# 42 HONEYSUCKLE DRIVE COTTAGE CREEK PRECINCT NEWCASTLE

STATE SIGNIFICANT DEVELOPMENT (SSD-10378)  
DEVELOPMENT MODIFICATION 2

ARCHITECTURAL DESIGN STATEMENT

NOVEMBER 2021

# 11.1 DESIGN CHANGES EAST SECTION

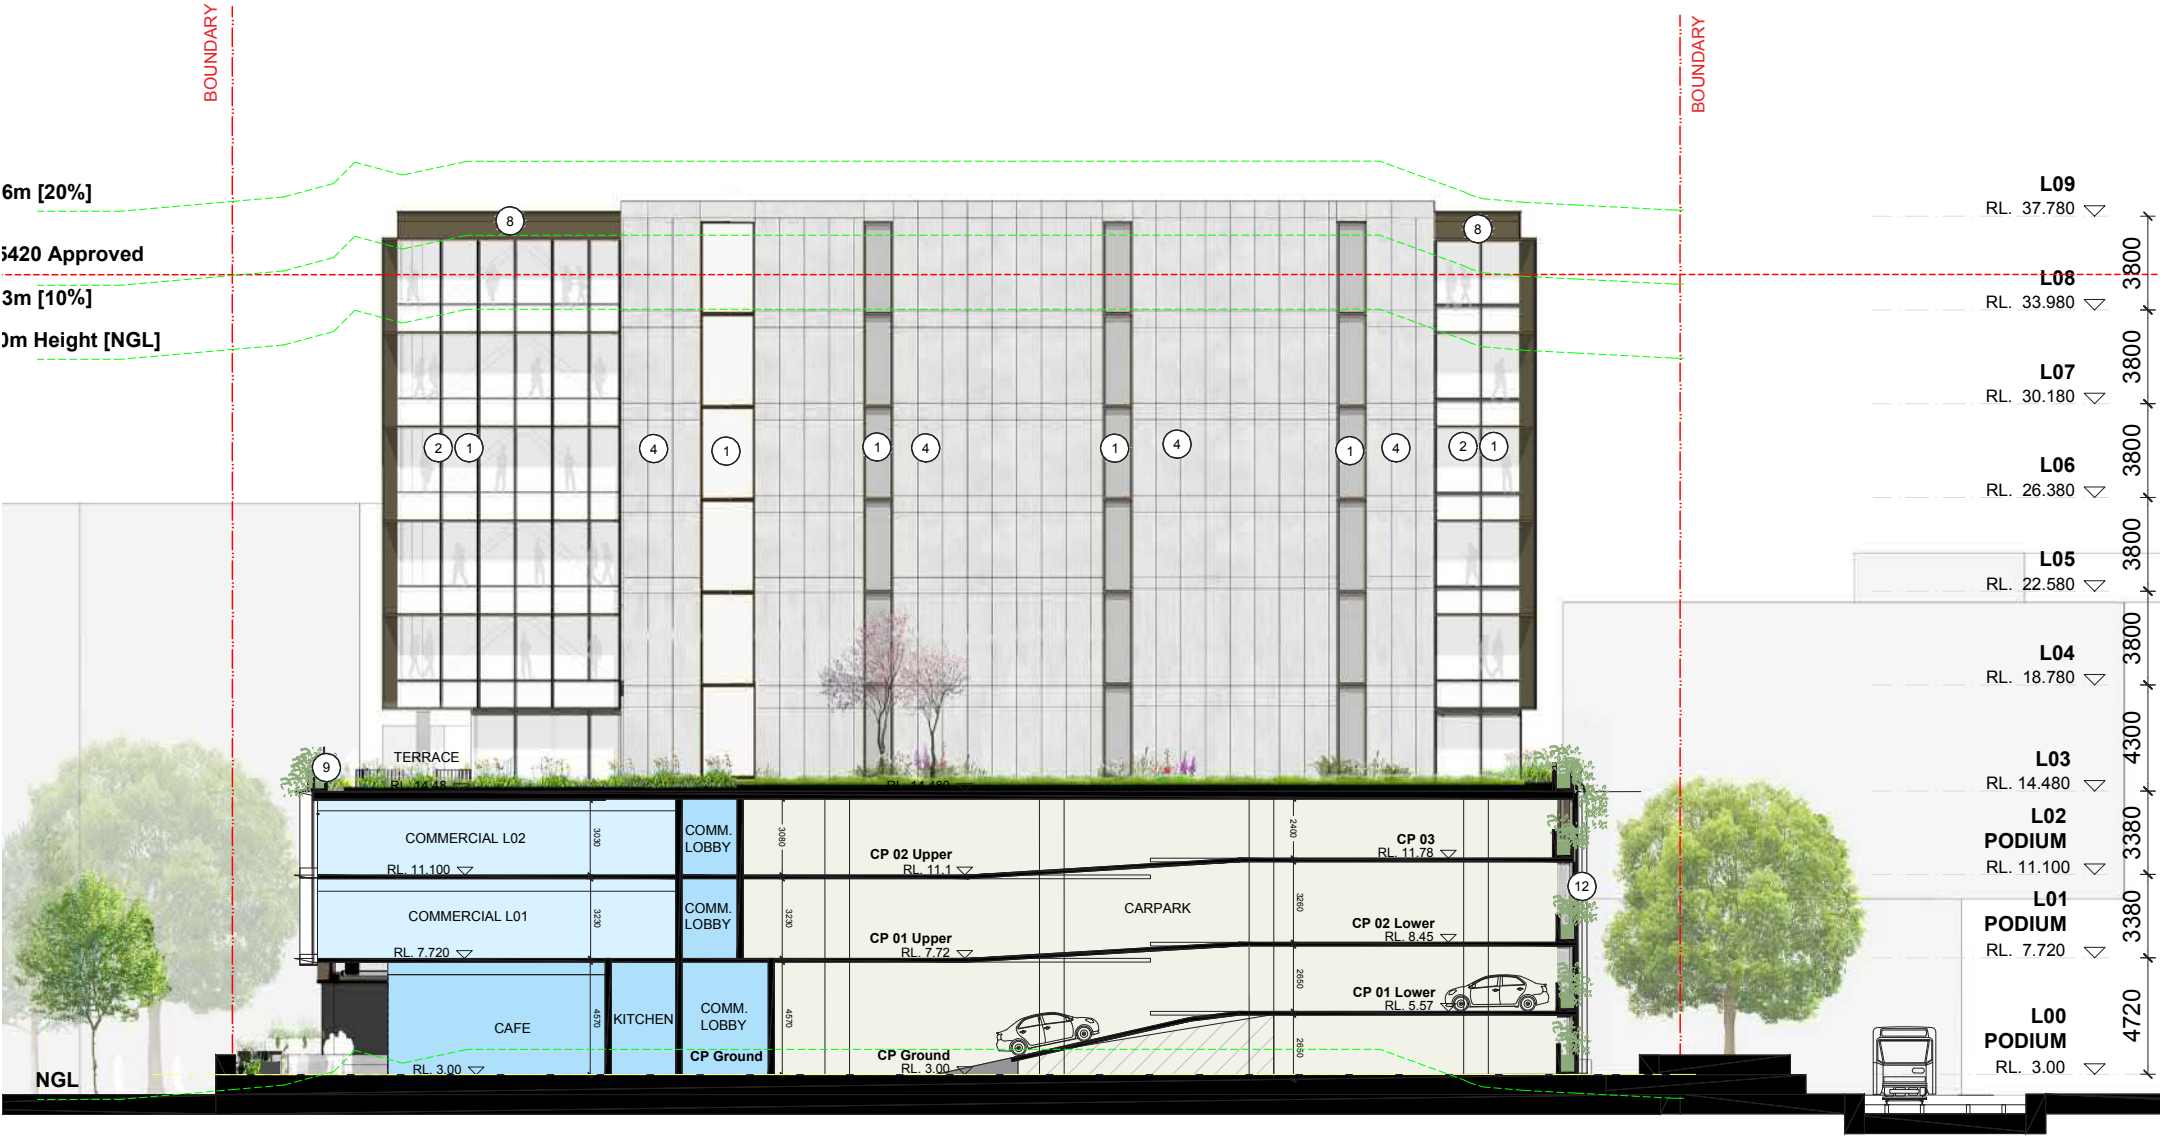
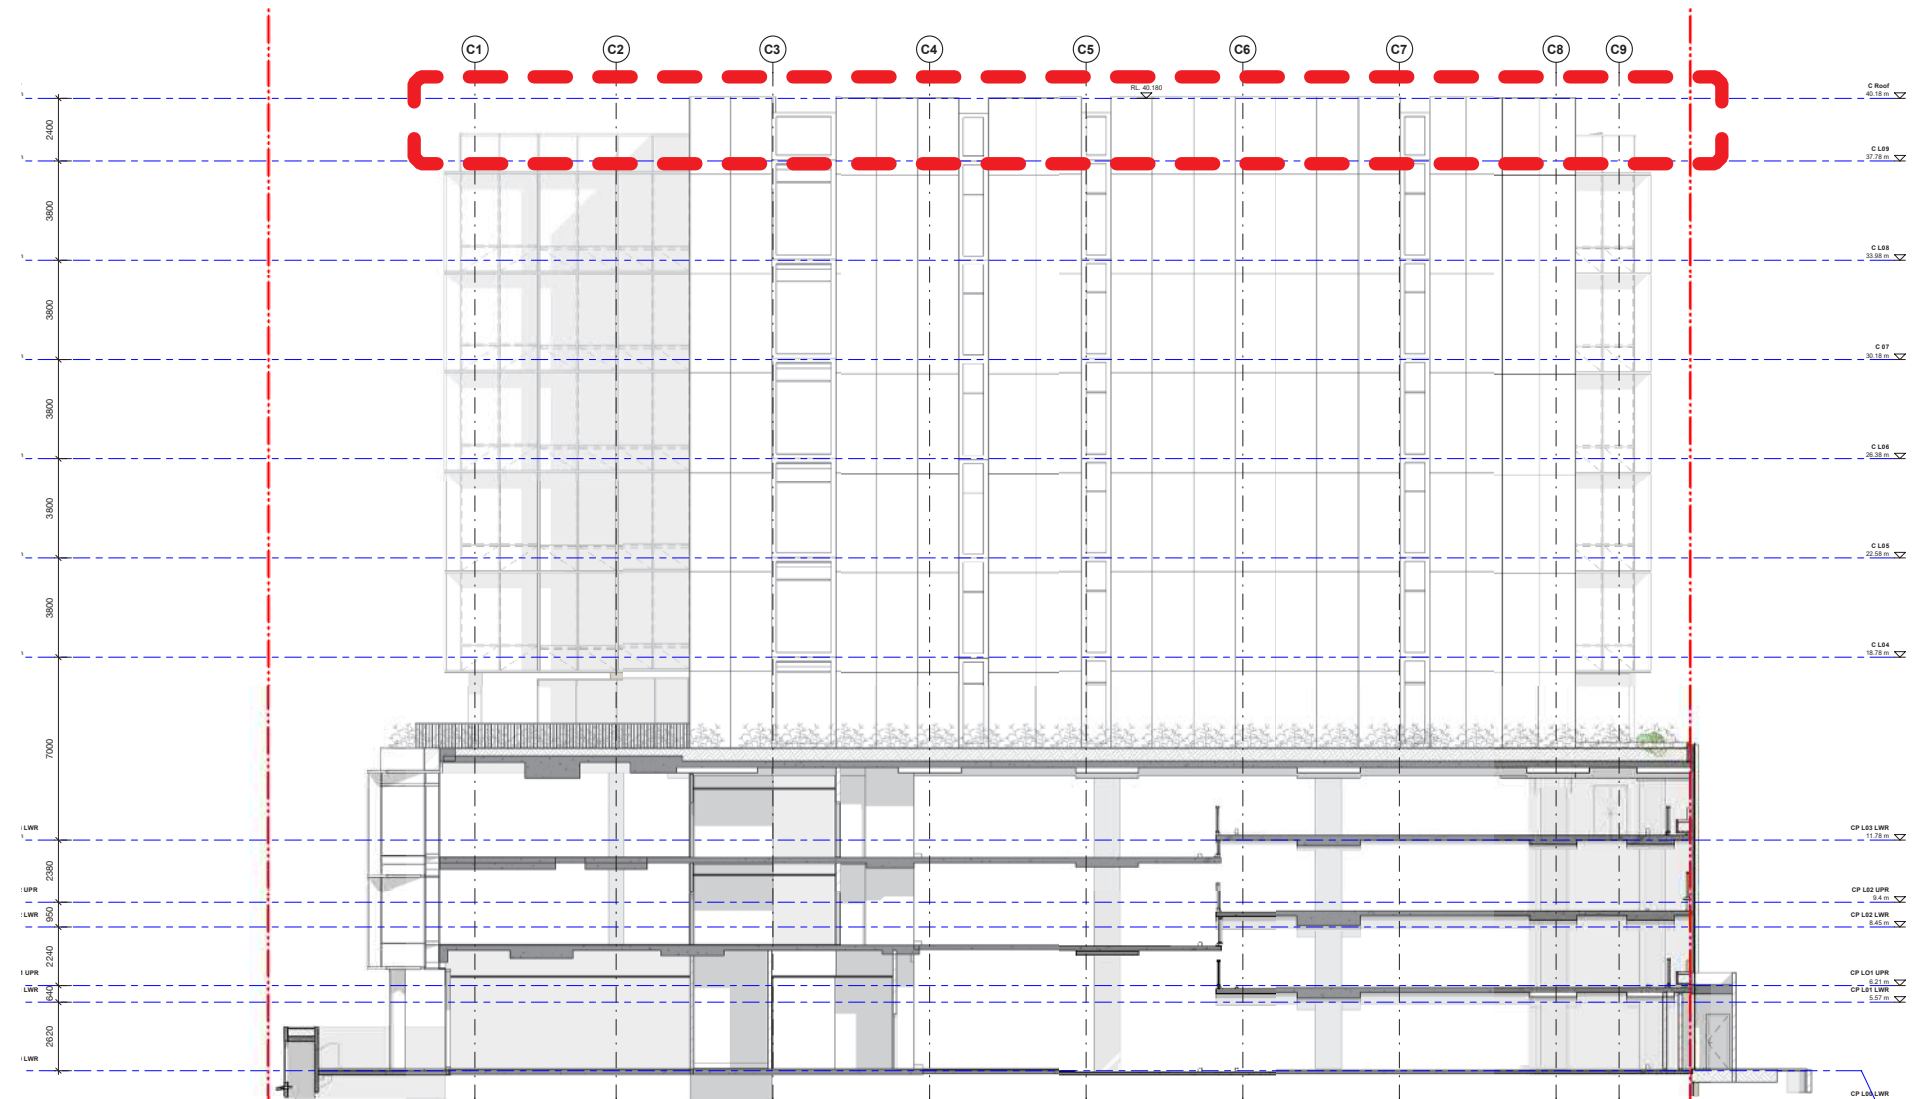
1 / Commercial tower height increased by 600mm to allow for additional plant height.

# 12.1 DESIGN CHANGES WEST SECTION

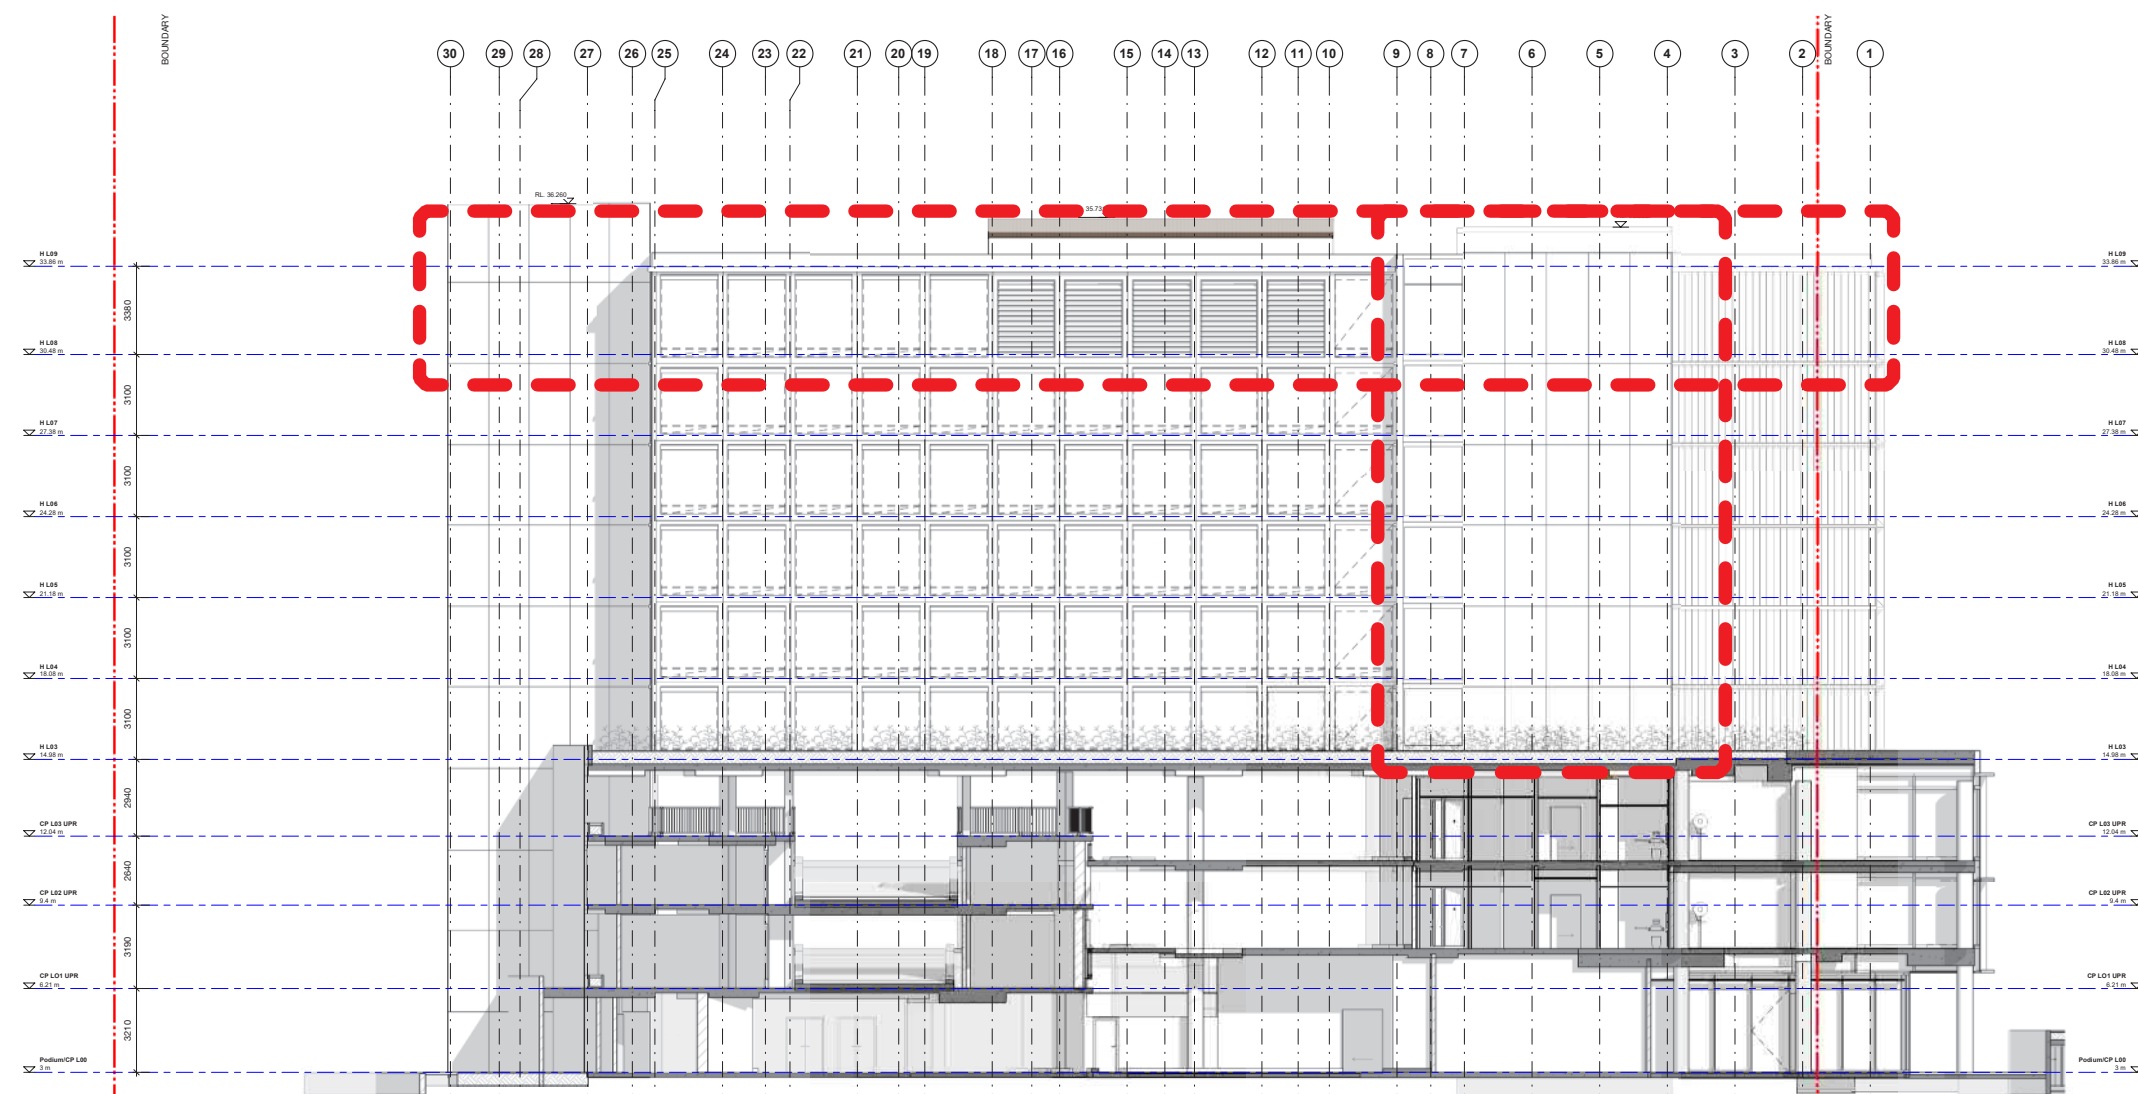
1 / Hotel slab to slab levels reduced from 3380mm down to 3100mm. This has resulted in an overall hotel building height reduction.

2 / Facade amended outside lift lobby. This is now concrete construction rather than glazing to increase privacy between the hotel and commercial tower.
